# LAKE NONA MIXED USE DISTRICT

### Applicant's Request:

Specific Parcel Master Plan (SPMP) approval for the conceptual design of the Lake Nona Mixed Use District.

**Updated:** January 23, 2014

# STREET HIERARCHY

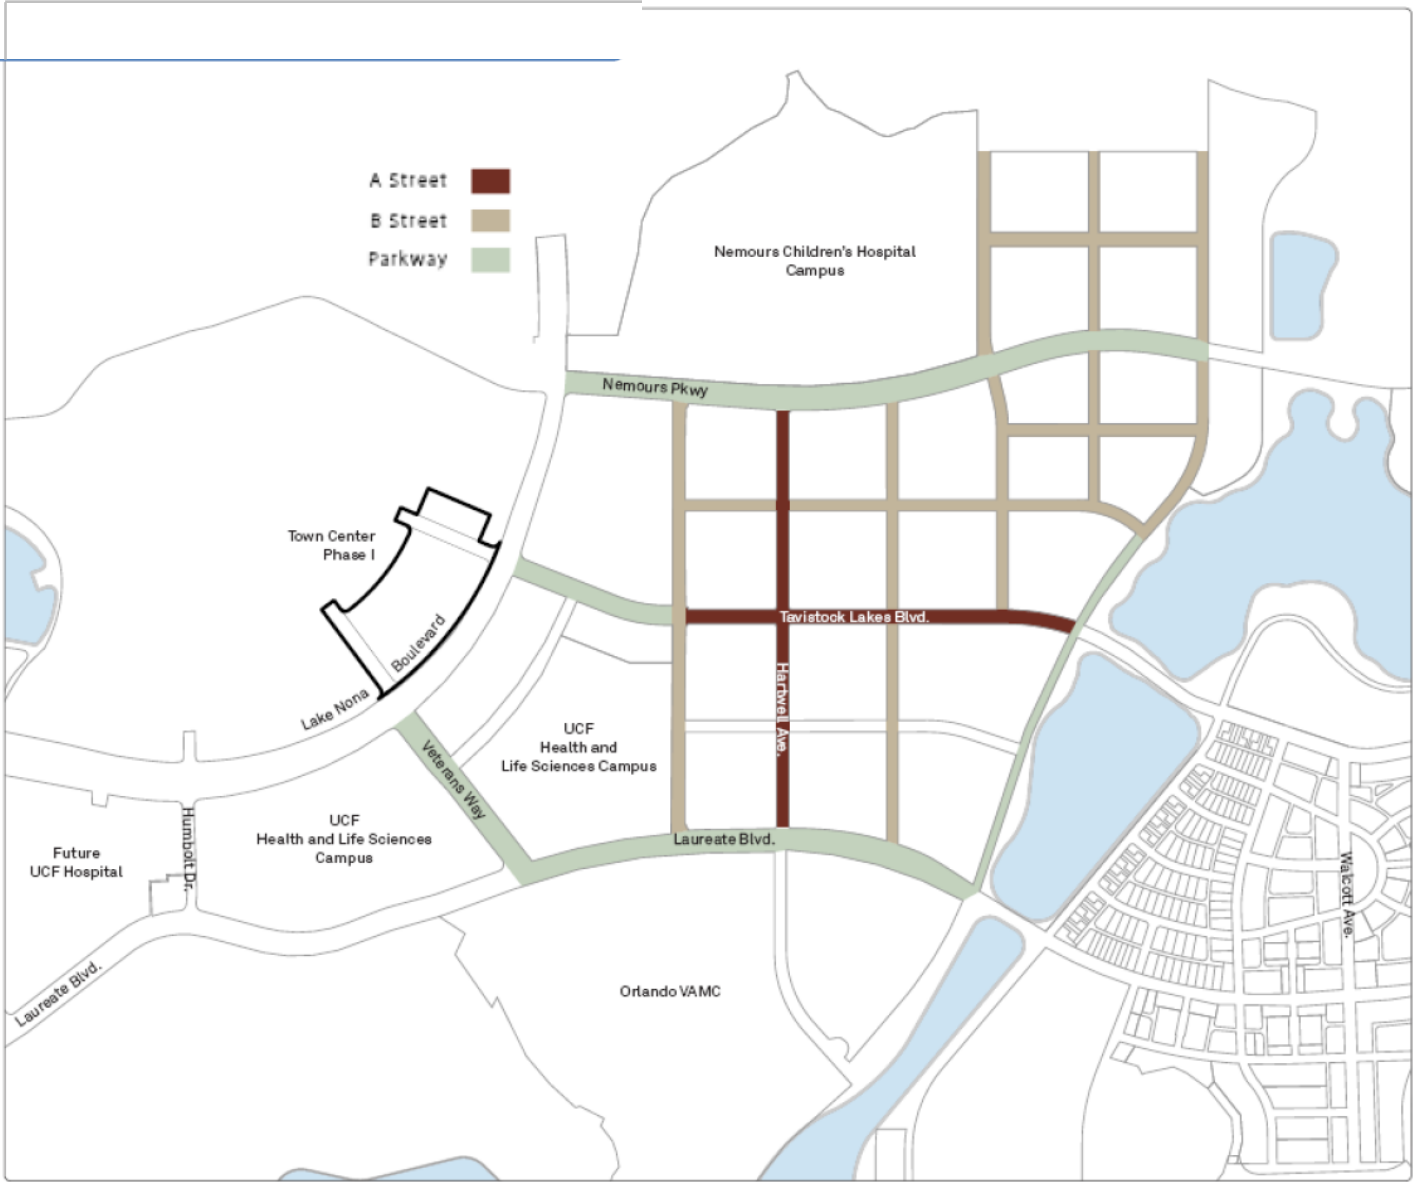
The Lake Nona Mixed Use District has 3 street types: “A” Streets, “B” Streets, and Parkways. The intent of these designations is to identify the minimum standard necessary to establish a cohesive district as it develops over time. The proposed street hierarchy, which is depicted on page 11 of this report, is designed to create consistent frontage along the “A” Streets and Parkways and to allow

Edges of blocks abutting "A" Streets and Parkways are required to be designed as the primary facades of the proposed buildings and pedestrian access to the building.

# MIXED USE DISTRICT BLOCK SIZES

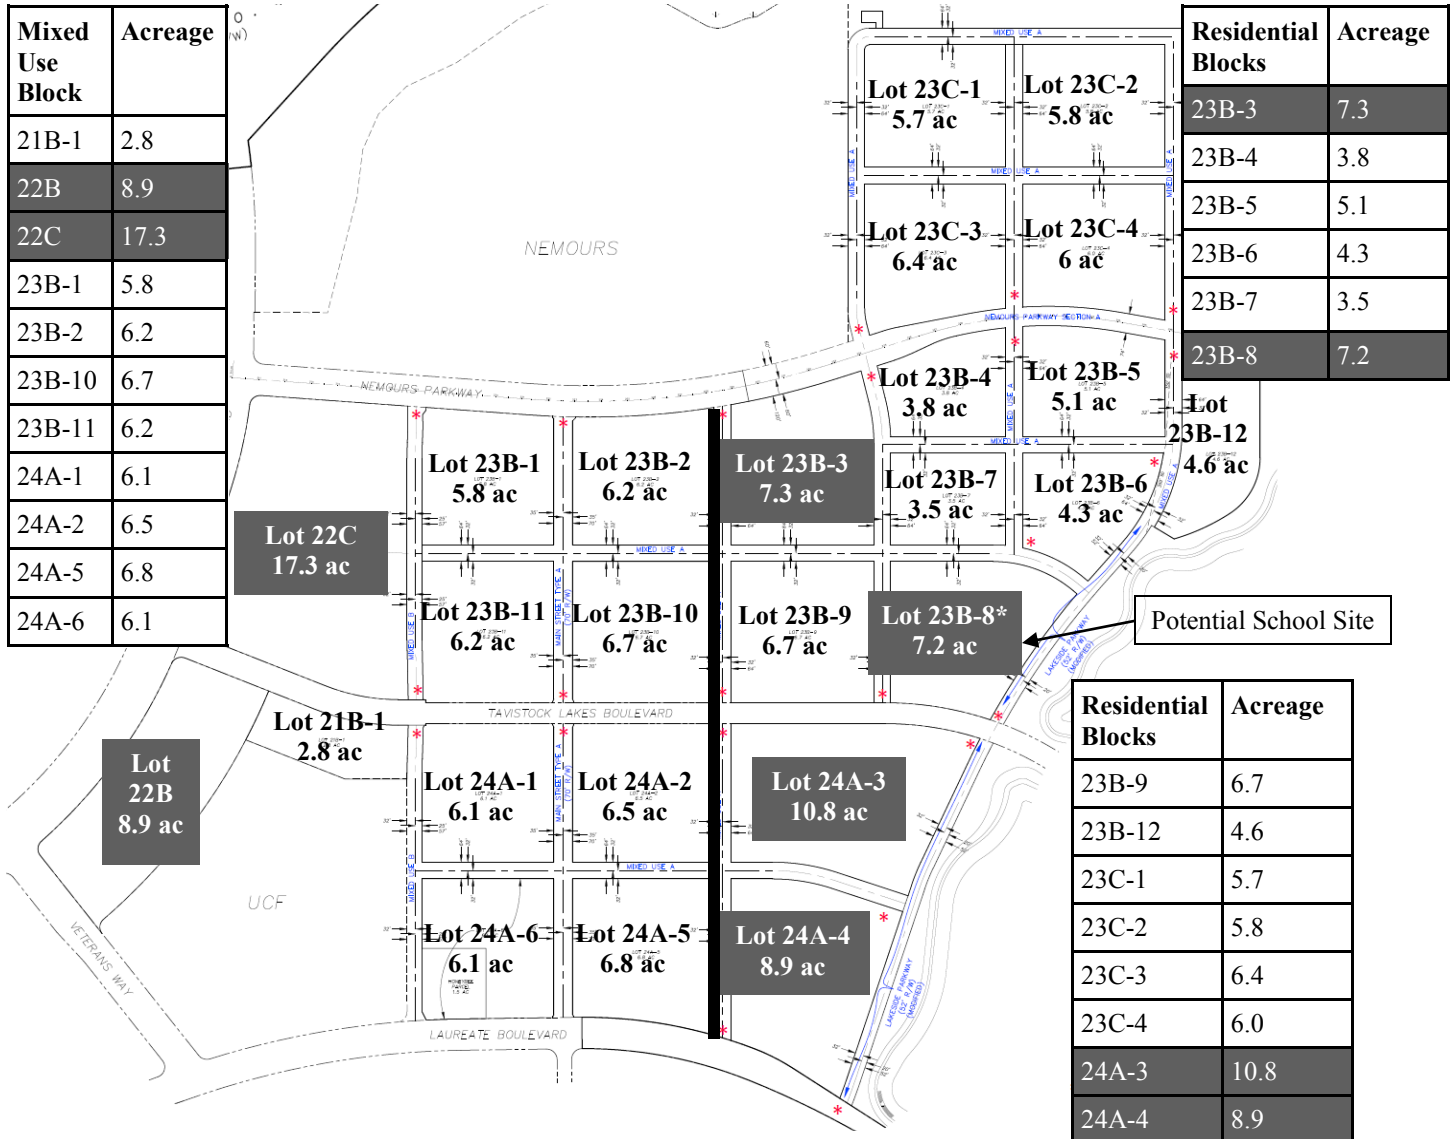
The maximum block size for the Mixed Use District is 7 acres. However, the following blocks may exceed the maximum block size standard: 22B, 22C, 23B-3, 23B-8, 24A-3, and 24A-4. Block 24B was left out of the revised graphic (Mixed Use Parcel south of Laureate Boulevard). The applicant shall revise the graphic to provide the acreage of Block 24B.

### Cross Sections

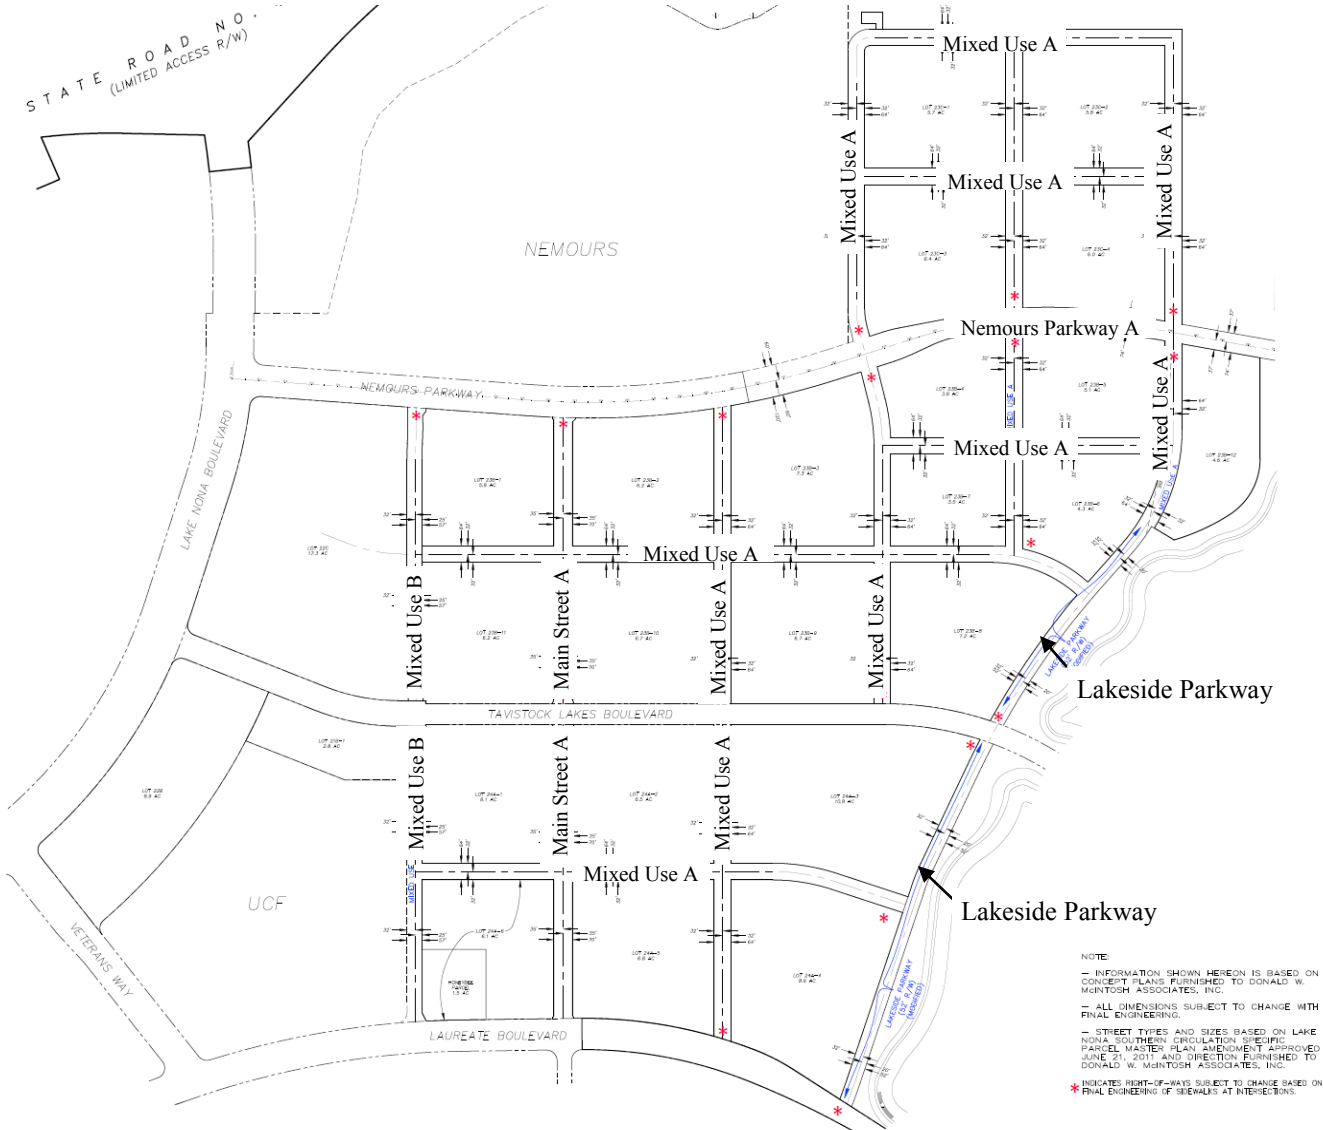
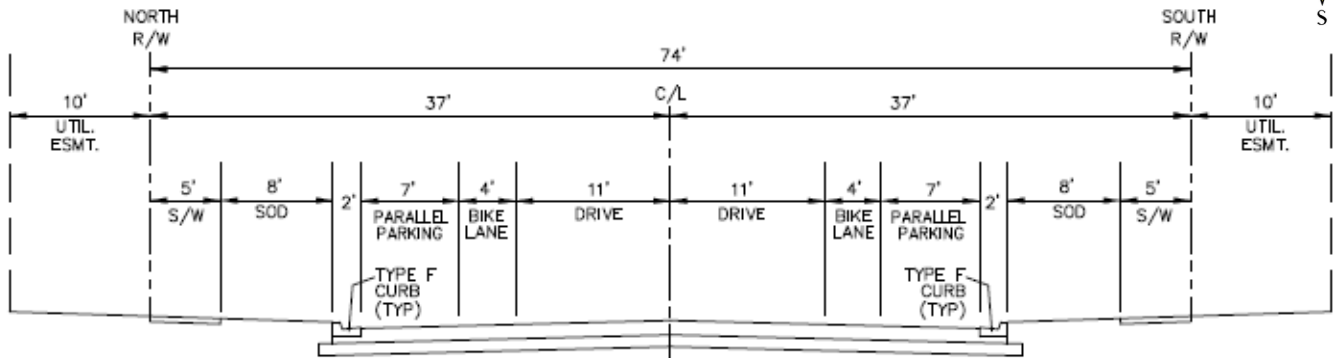
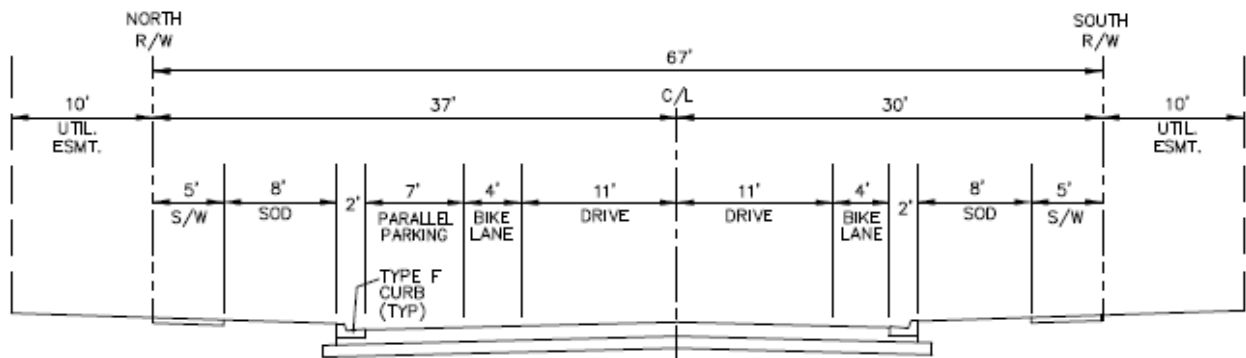
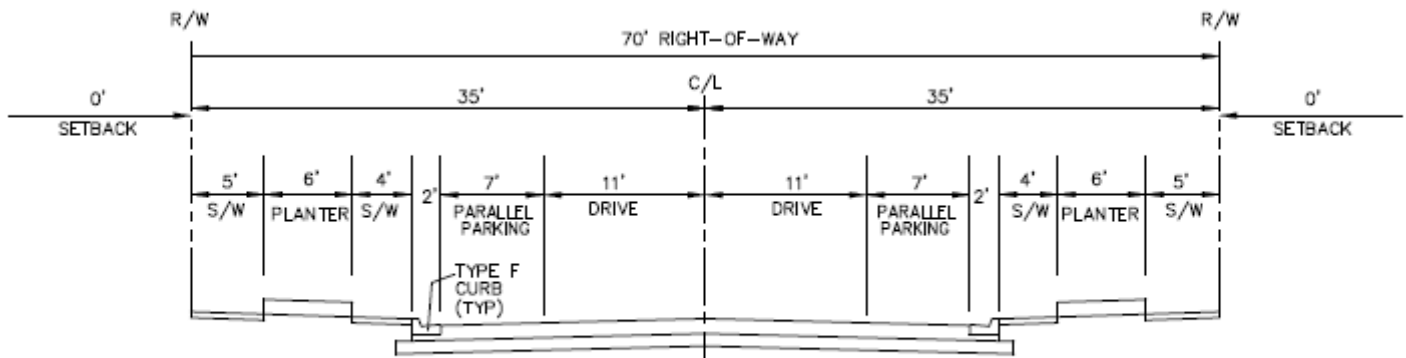
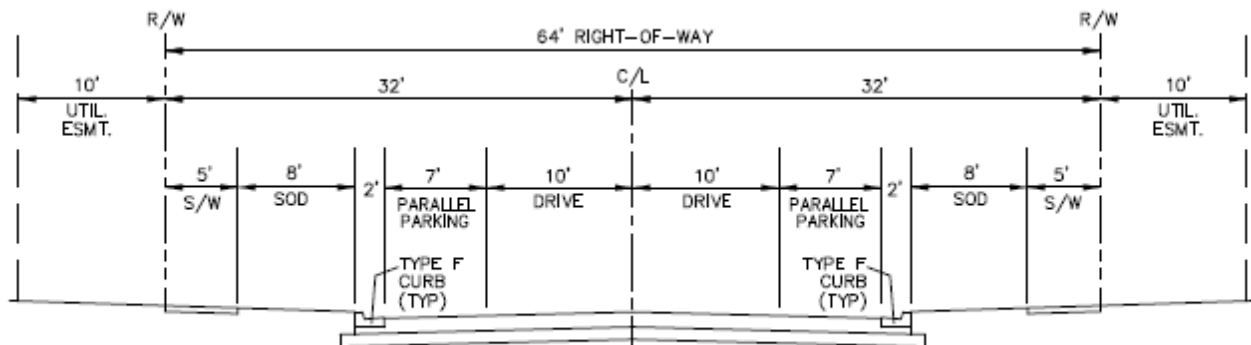
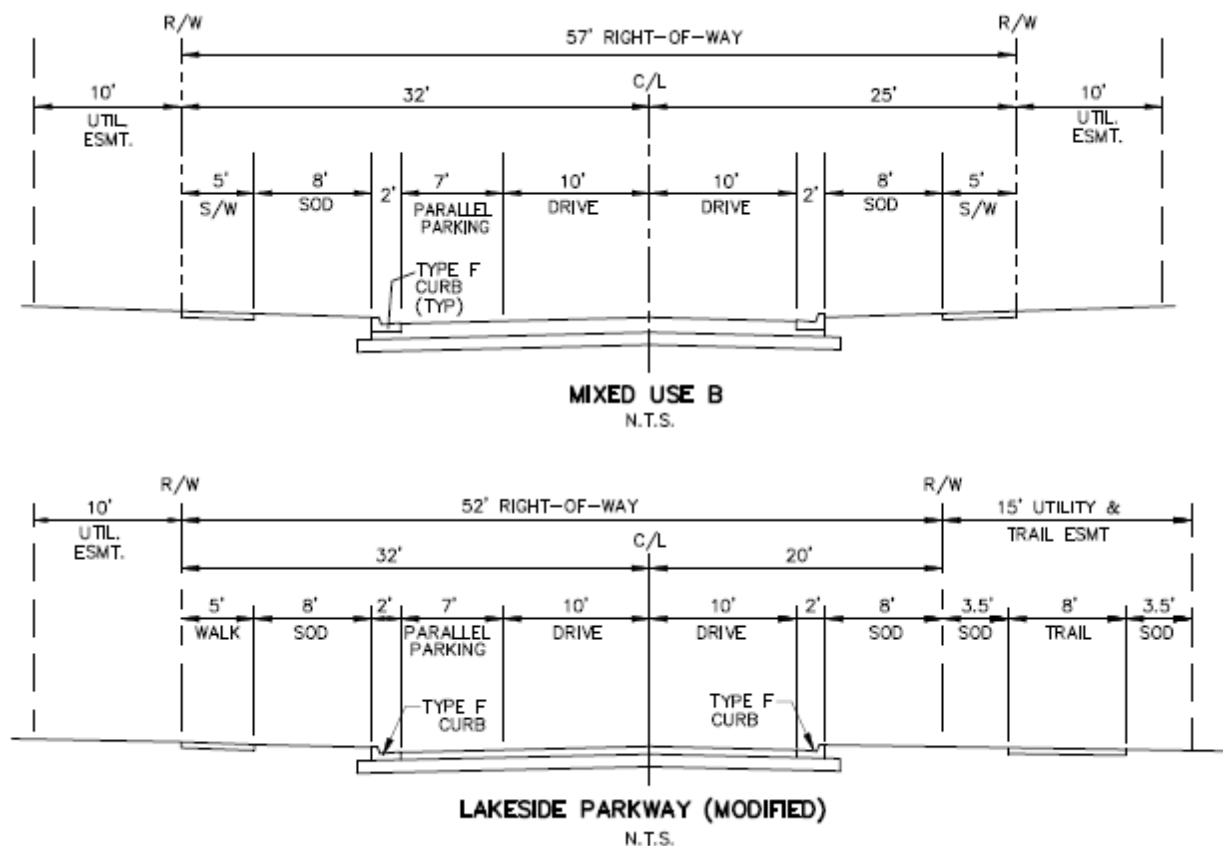
The applicant has provided cross sections for the street network in this Mixed Use District. After review of these cross section, many differ from the ones depicted within the Lake Nona Southern Circulation Plan. In order for these cross sections to be consistent with the Southern Circulation Plan, the applicant shall request an amendment to the Southern Circulation Plan SPMP for the following sections: Main Street A (Exhibit 2.11 in the Southern Circulation Plan), Mixed Use A (Exhibit 2.12 in the Southern Circulation Plan), Mixed Use B (Exhibit 2.13 in the Southern Circulation Plan), Nemours Parkway A and B (Exhibit 2.14 in the Southern Circulation Plan), and the Lakeside Parkway (Exhibit 2.17 in the Southern Circulation Plan).

The proposed cross sections have not yet been reviewed by Transportation Engineering. The applicant shall request an amendment to the Lake Nona Southern Circulation Plan for the following cross sections in order to be consistent: Main Street A (Exhibit 2.11 in the Southern Circulation Plan), Mixed Use A (Exhibit 2.12 in the Southern Circulation Plan), Mixed Use B (Exhibit 2.13 in the Southern Circulation Plan), Nemours Parkway A and B (Exhibit 2.14 in the Southern Circulation Plan), and the Lakeside Parkway (Exhibit 2.17 in the Southern Circulation Plan). Any revisions required as part of the Southern Circulation SPMP amendment shall supersede the cross sections shown in this Mixed Use District SPMP.
